# **Energy Storage ISO Rule Amendments Stakeholder Session 3**

February 2, 2023

The AESO is consulting with Stakeholders on the development of the proposed Energy Storage ISO Rule Amendments that will:

## Measuring Frequency Response when under Dispatch to Provide Regulating Reserve

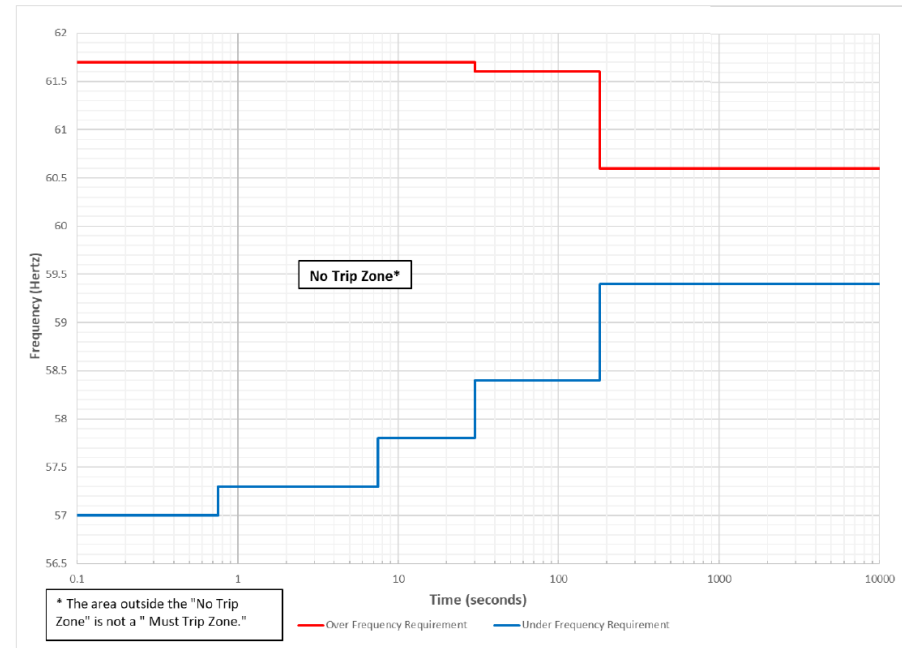
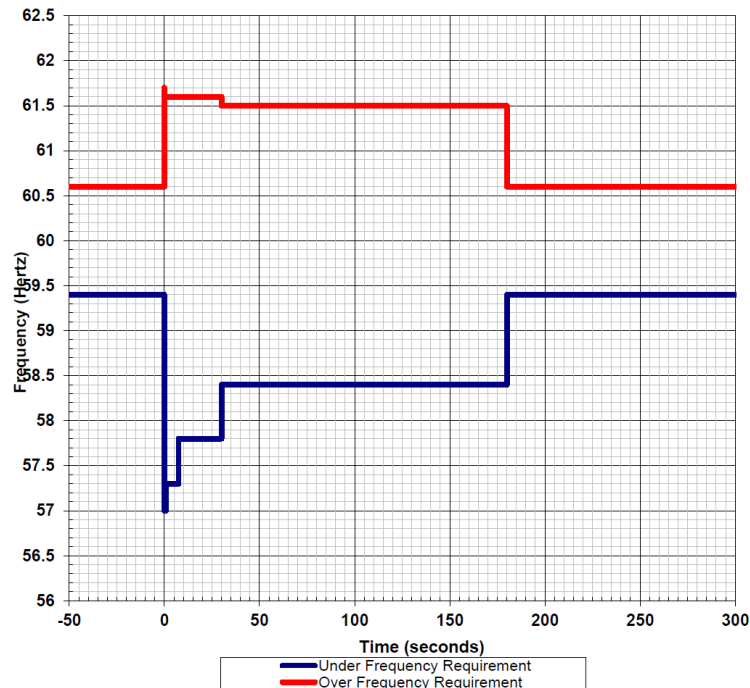
- Comments and Questions from Stakeholders
  - Some rules make references to “stator winding terminals”
    - At times, ambiguous about application of this terminology to technology
  - Clarify changes in Appendix 1
- As much as possible, we tried to make the rules technology agnostic; however, there are places where the technology still needs to be referenced

- 8 For the purpose of subsection 6, frequency response performance is measured at:
- (a) the stator winding terminals of a **generating unit; or energy storage resource;**
  - (b) the circuit breaker or disconnection device that is electrically closest to each load;
  - (c) the alternating current terminal closest to each inverter based technology;

Add ‘synchronous’ before energy storage resource in this instance (from Section 205.4)

### Operation at Maximum Authorized Charging Power

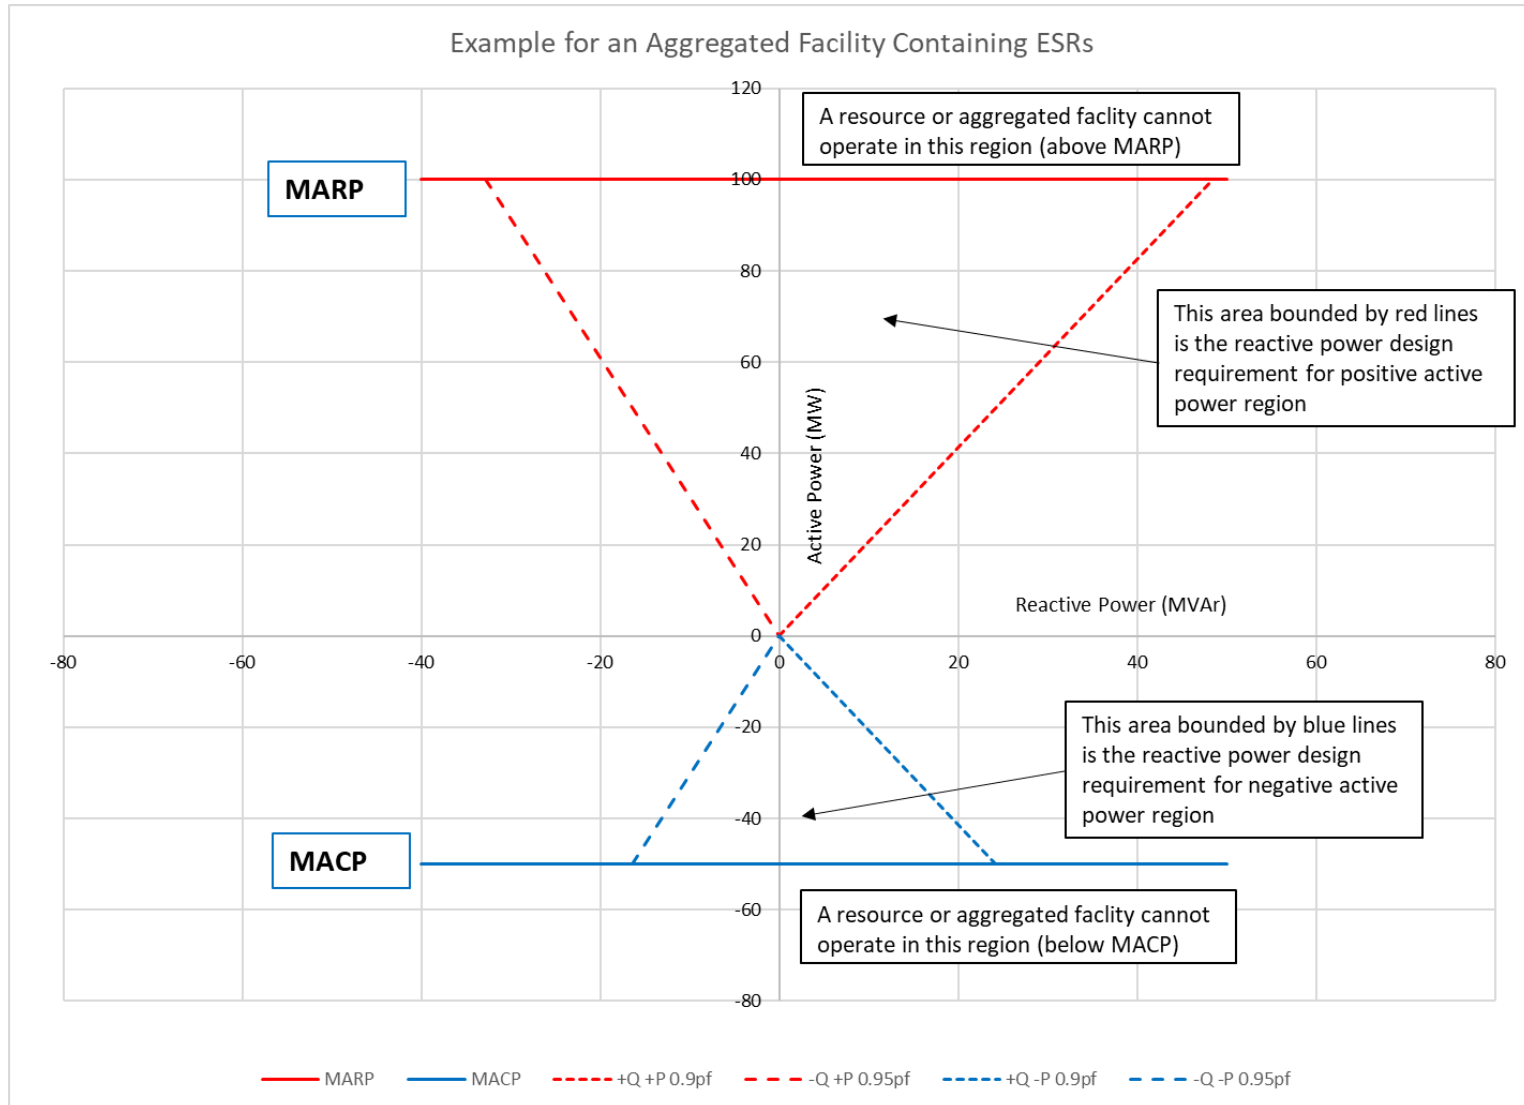
- Comments and questions from Stakeholders
  - Clarify the requirement to exclude auxiliary power from MARP and MACP
  - Clarify the operation 'below MACP' and the singing convention to be employed

- For purposes of applying MARP and MACP to the rules, the intent is that both are taken as signed quantities
- Instances where 'between MARP and MACP' would be interpreted as  $(\text{MARP} - \text{MACP})$ , where MACP is negative
  - *i.e.*, same as  $\text{MARP} + |\text{MACP}|$
- Auxiliary power should not be included in determining MARP and MACP
  - MARP and MACP are based on the resource attributes only

# Section 503.5, Voltage Ride-Through

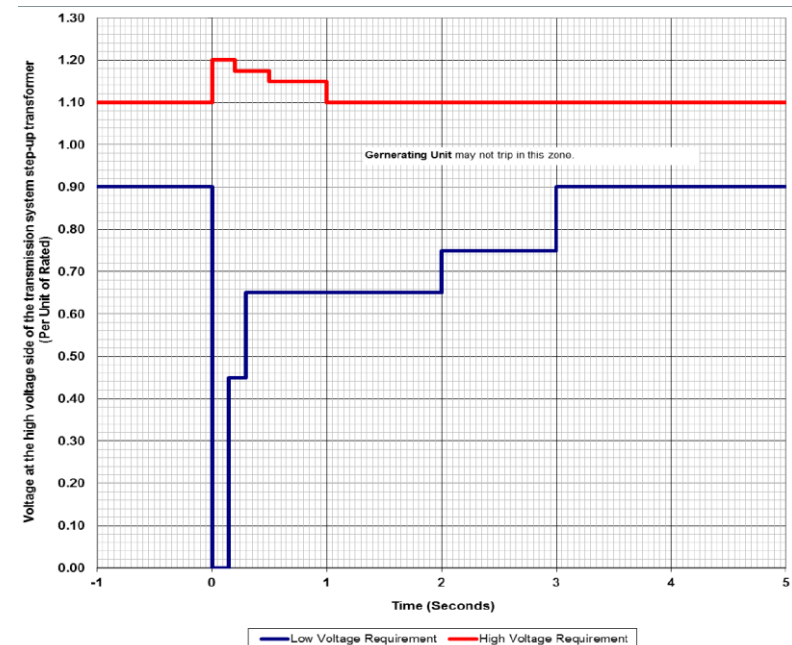
- Comments and Questions from Stakeholders
  - Section 503.5 does not adequately deal with the legacy treatment and ‘existing generating units’; how will this be addressed?
  - What entity determines normal clearing time?

- ‘Existing’ generator needs to meet the requirements for voltage ride through in place at the time of their approval.
- Normal clearing time to be determined by legal owners of the facilities within applicable rule and standards
- Suggest edits to align this graph to the frequency ride through requirements

# Section 503.6, Frequency and Speed Governing

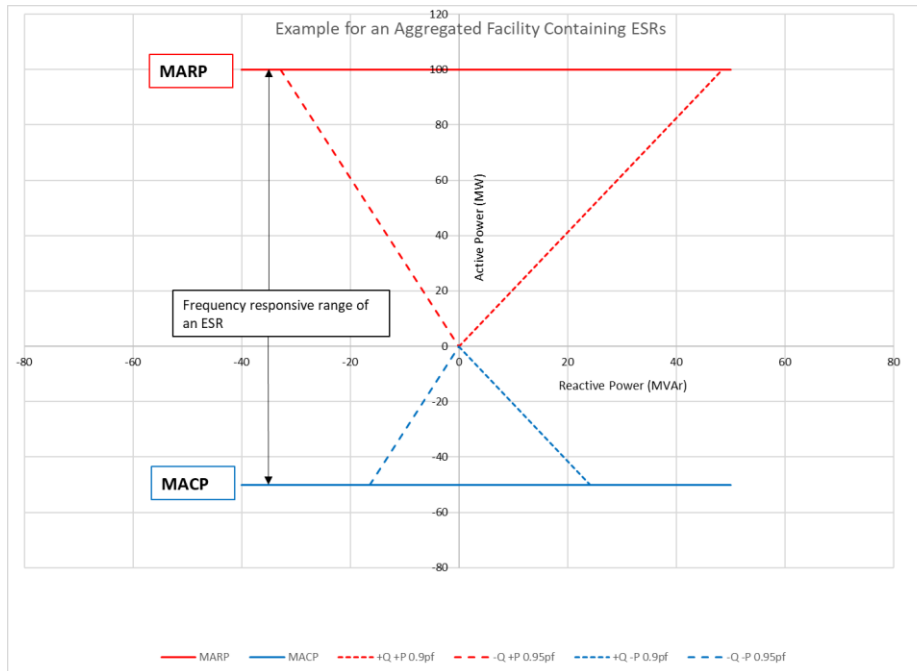
- Comments and Questions from Stakeholders
  - Recommend removing references to ‘synchronous machine’
  - The droop setting should be based on active power output rather than MARP
  - Clarify the droop response between MARP and MACP
  - Does an ESR need to be frequency responsive while consuming active power?

- The conventional definition of droop is the amount of speed change that is necessary to cause the prime mover mechanism to move through 100% of its range
- Basing droop on current active power output would degrade the effective frequency response of resources at low levels of production

Estimated effective droop response  
for a MARP=100MW Generating  
Unit for 0.5Hz frequency dip at 5%  
droop:

$$\begin{aligned}\Delta P &= (\Delta f/60)*(1/R)*MARP \\ \Delta P &= (0.5/60)*(1/.05)*100 \\ \Delta P &= 16.67 \text{ MW}\end{aligned}$$

Estimated effective droop response  
for a MACP=-10MW,  
MARP=100MW Battery System for  
0.5Hz frequency dip at 5% droop:

$$\begin{aligned}\Delta P &= (\Delta f/60)*(1/R)*MARP-MACP \\ \Delta P &= (0.5/60)*(1/.05)*100-(-10) \\ \Delta P &= 18.33 \text{ MW}\end{aligned}$$

- ESRs are a unique resource that have unique properties, this technology is intended to enhance frequency response in both power producing and consuming modes
- The AESO believes that the frequency responsive nature of ESRs over the full spectrum is important to the reliability of the grid
